This Service Information bulletin supersedes SI M11 01 12 **dated June 2012.**

NEW designates changes to this revision

Engine Oil Leak

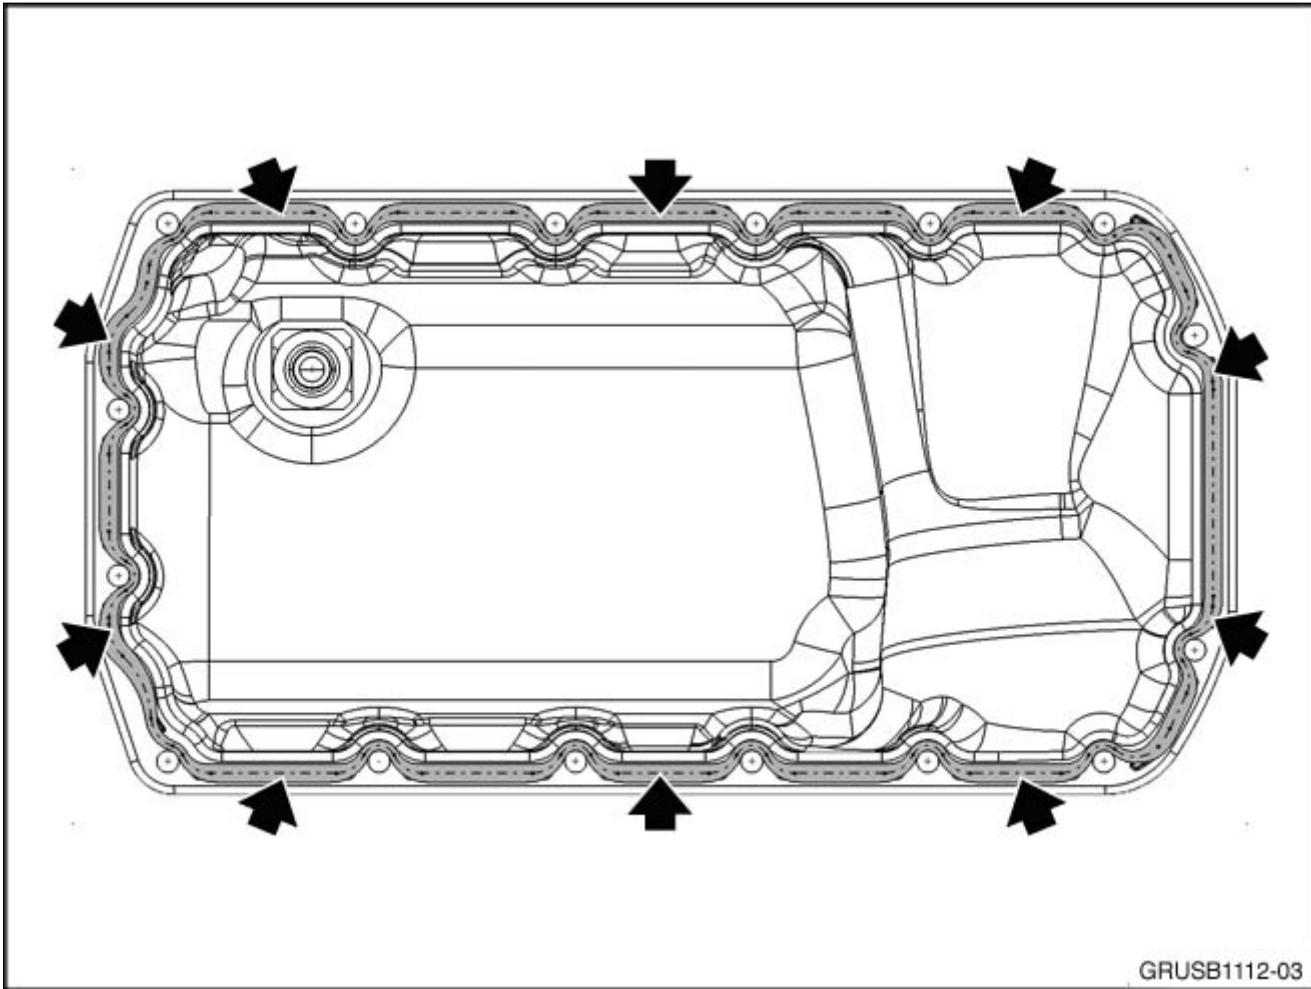
1. Disconnect the oil pump volume control solenoid valve electrical connection per Repair Instructions 11 41 519 "Removing and installing or replacing the solenoid valve (engine oil pump)."

Inspect the electrical connector; if no engine oil is found inside the electrical connector, replace the oil pump volume control solenoid valve only. See Repair Instructions 11 41 519. If engine oil is found inside the electrical connector, proceed to step 2.
